**PLAN REVIEW CONDITIONS**

Permit No: PRCOM20200445  
Project Title: MID-CONTINENT PUBLIC LIBRARY - COLBERN ROAD  
Project Address: 1000 NE COLBERN RD, LEES SUMMIT, MO 64064  
Parcel Number: 52500011300000000  
Location / Legal: RICE ACRES LOT 1  
Description:  
Type of Work: NEW COMMERCIAL  
Occupancy Group: ASSEMBLY FOR OUTDOOR ACTIVITIES INCL. STADIUMS, GRANDSTAND, AMUSEMENT PARKS  
Description: NEW LIBRARY

## **Plan Review Conditions Response**

## Supplemental Instructions #03

UNDERGROUND PLUMBING  
PLAN - AREA A

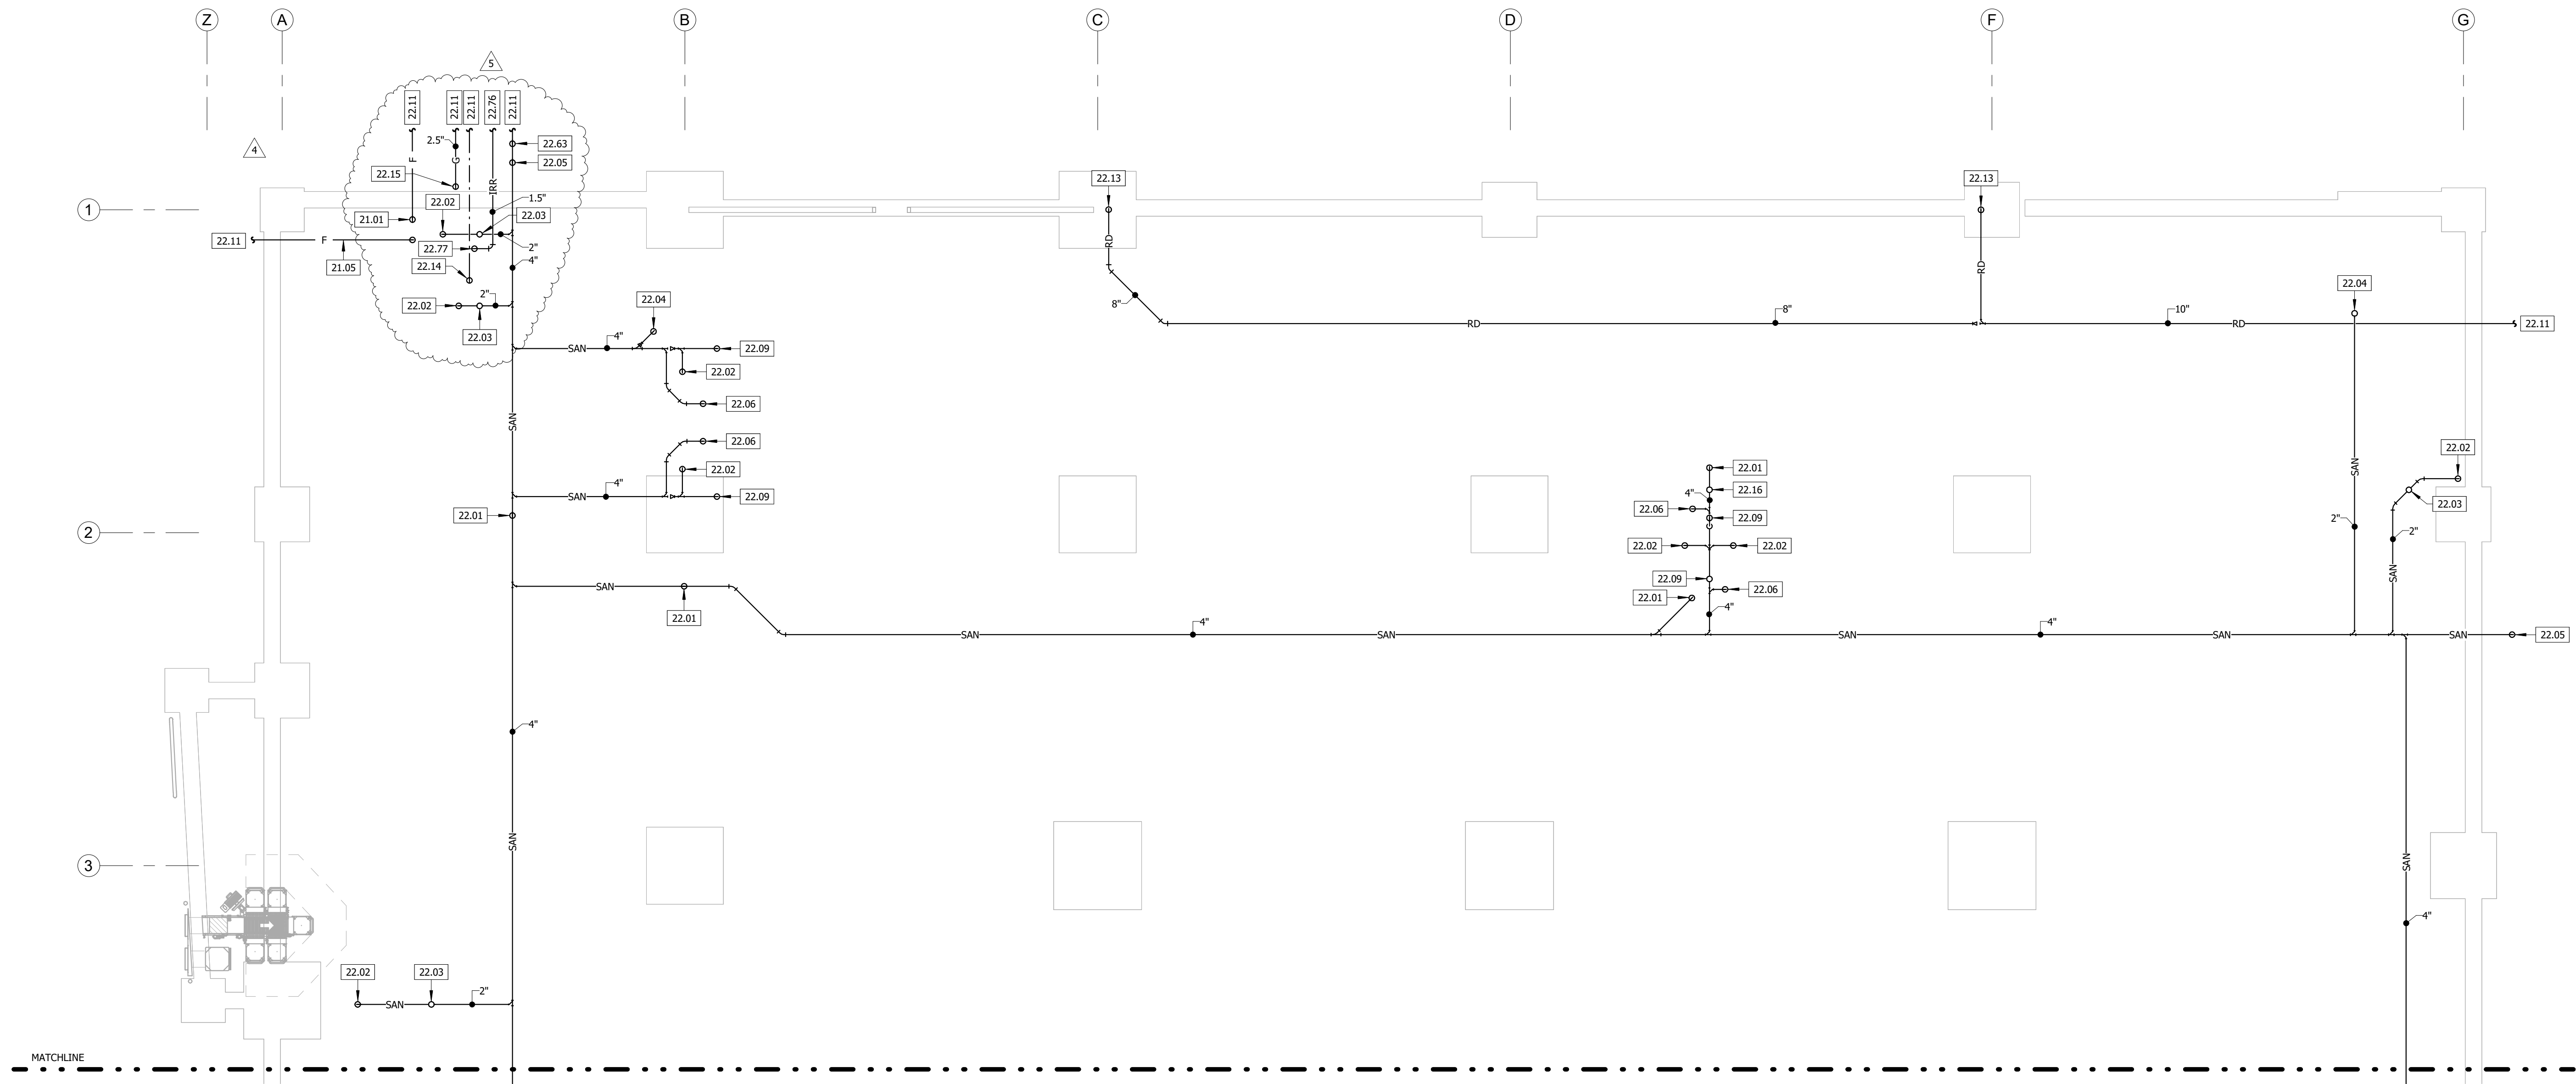
1. Refer to detail 1/P100 – Underground Plumbing Plan – Area A:
  - a. Revise waste, vent, and cold water piping per attached sheet SI03-P100.
  - b. Revise keynote 22.64 per attached sheet SI03-P100.

P101  
UNDERGROUND PLUMBING  
PLAN - AREA B

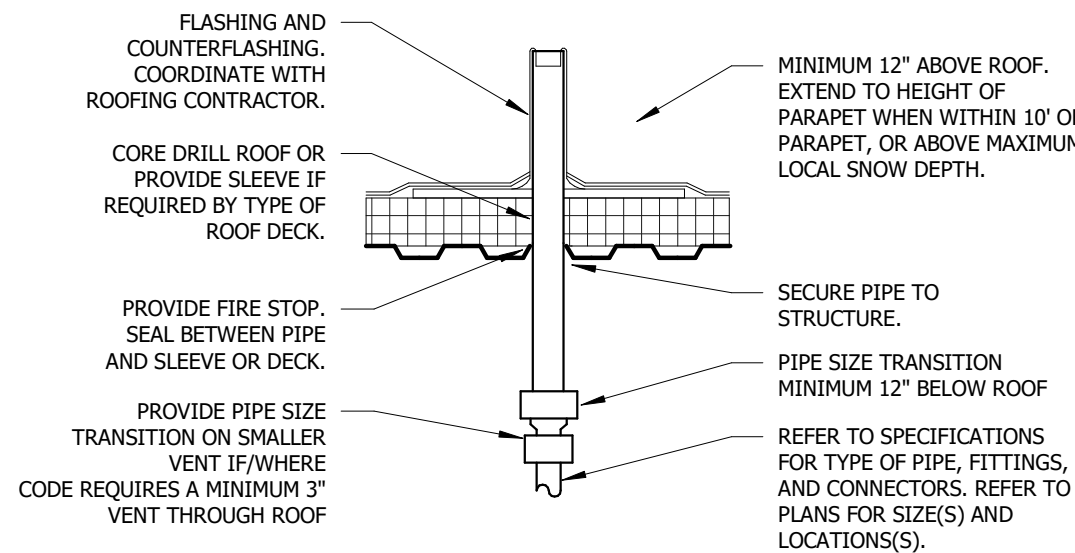
**3/19/20 - P-series drawings must be coordinated with L600 series. i.e. Landscaping irrigation plans specify a connection to the domestic water system but the plumbing drawings do not.**

1. Refer to detail 1/P101 – Underground Plumbing Plan – Area B:
  - a. Add irrigation piping underground per attached sheet SI03-P101.
  - b. Add keynotes 22.76 and 22.77 per attached sheet SI03-P101.

11. See attached updated sheet A400 showing revisions to doors and hardware corresponding with previously submitted plans.
12. Civil, Landscaping, and MEP plans have all been updated to show the irrigation tap, backflow preventer, and meter inside the building. Civil and Landscaping plans have been submitted with the FDP submittal. Attached are the updated L601, P101, and P200 reflecting this change.

3 ENLARGED PLUMBING PLAN - STAFF AREA

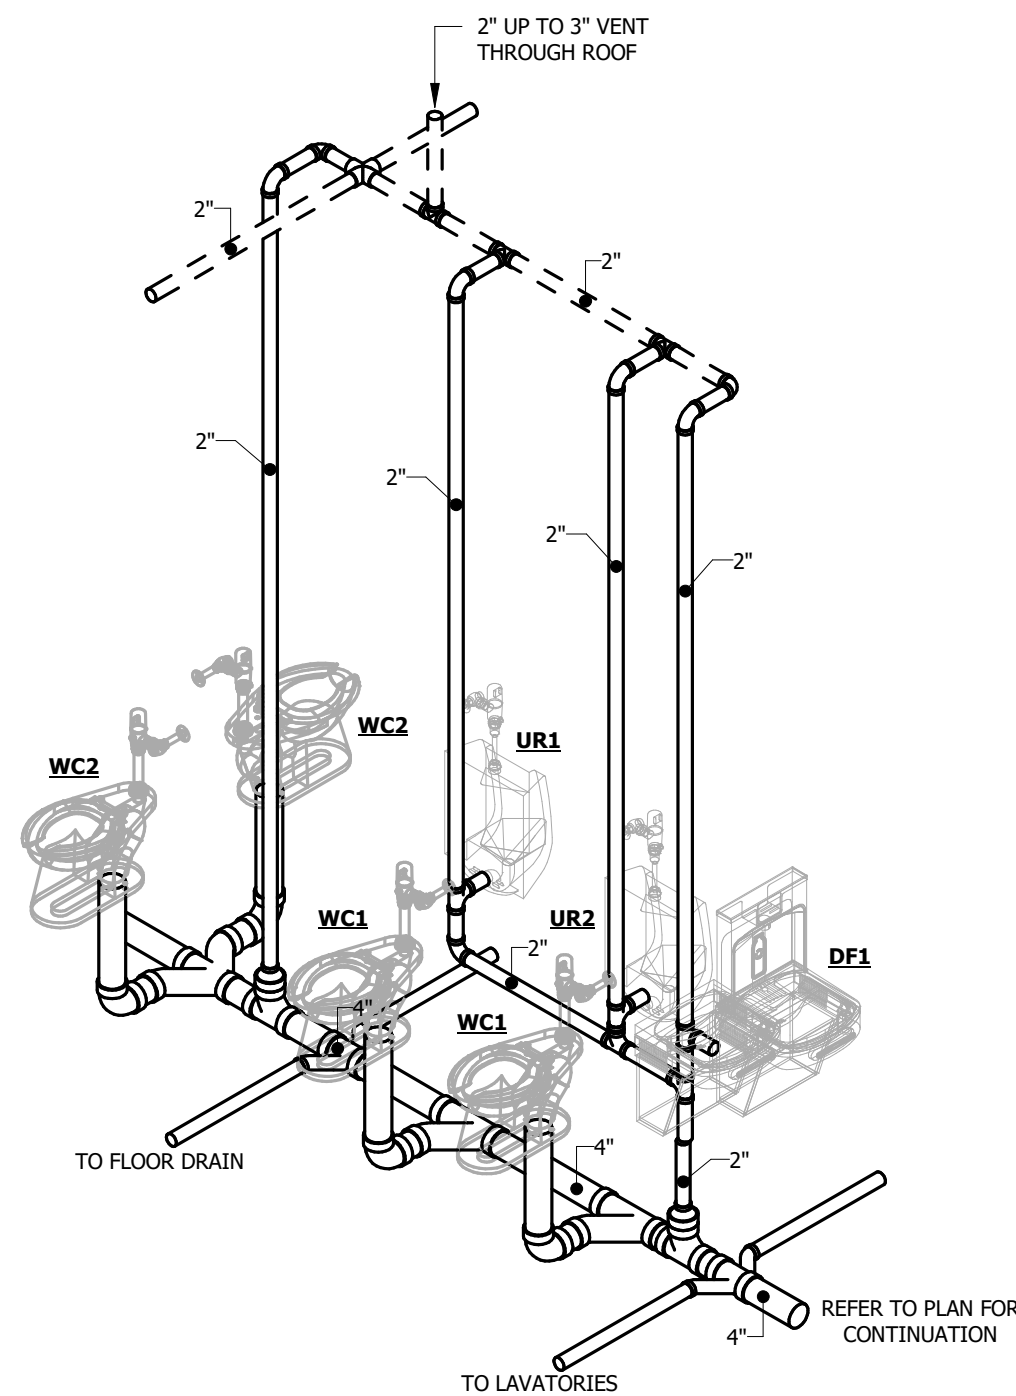
- a. Add irrigation piping in 118 Sprinkler per attached sheet SI03-P200.
  - b. Shift natural gas service entrance and meter east as required for trash enclosure per attached sheet SI03-P200.

- c. Add keynotes 22.78 and 22.79 per attached sheet SI03-P200.

1 ENLARGED PLUMBING PLAN - RESTROOM AND CAFE

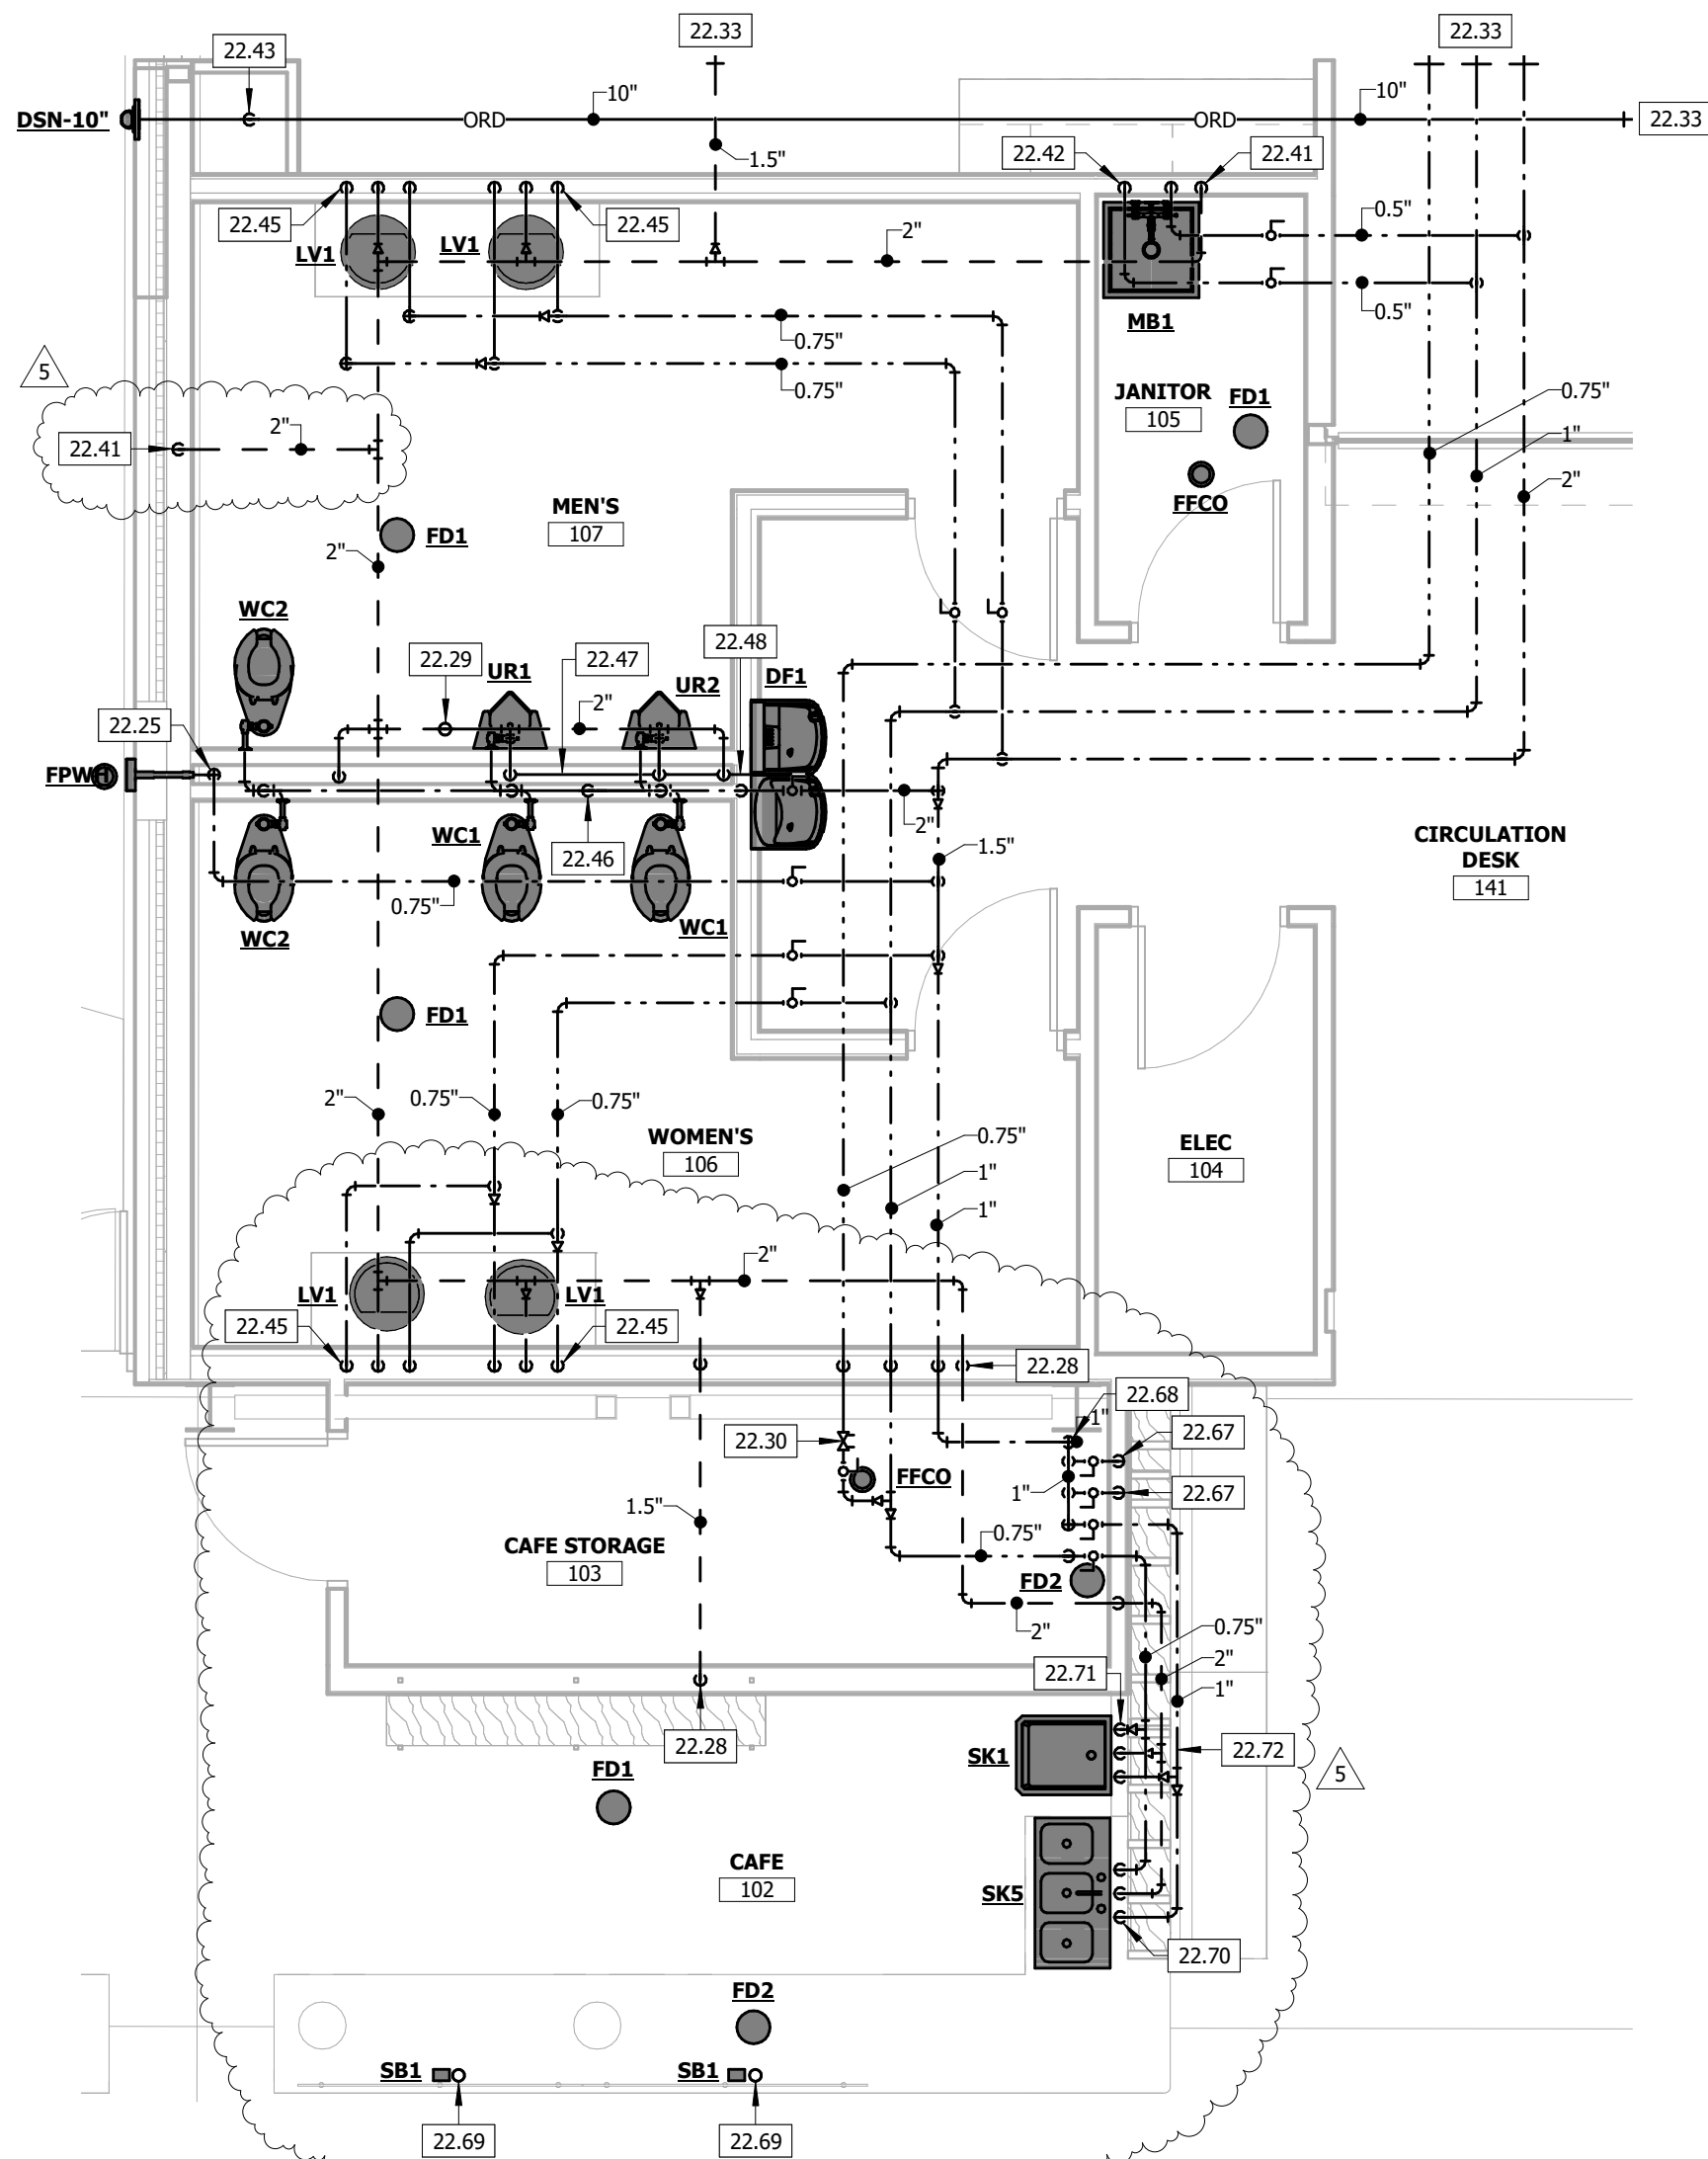
1. Refer to detail 1/P200 – Enlarged Plumbing Plan – Restrooms and Café:
  - a. Remove Supply Box SB1 in 102 Café per attached sheet SI03-P200.
  - b. Add Three Compartment Sink SK5 and Floor Drain FD2 in 102 Café per attached sheet SI03-P200.

- c. Revise Hand Sink SK1 in 102 Café per attached sheet SI03-P200.
  - d. Revise Supply Box SB1 locations in 102 Café per attached sheet SI03-P200.
  - e. Revise hot and cold water and vent piping per attached sheet SI03-P200.

- f. Add vent piping per attached sheet SI03-P200.
  - g. Revise keynotes 22.69, 22.70, 22.71, and 22.72 per attached sheet SI03-P200.
2. Refer to detail 3/P200 – Enlarged Plumbing Plan – Staff Area:

4. Contractor (JE Dunn) will obtain a demolition permit for that scope of work.
5. The Health department has approved the plan with the addition of a small three compartment sink as shown on the attached MEP sheets P100, P200, and P300 and architectural sheets A100, A101, and A150.
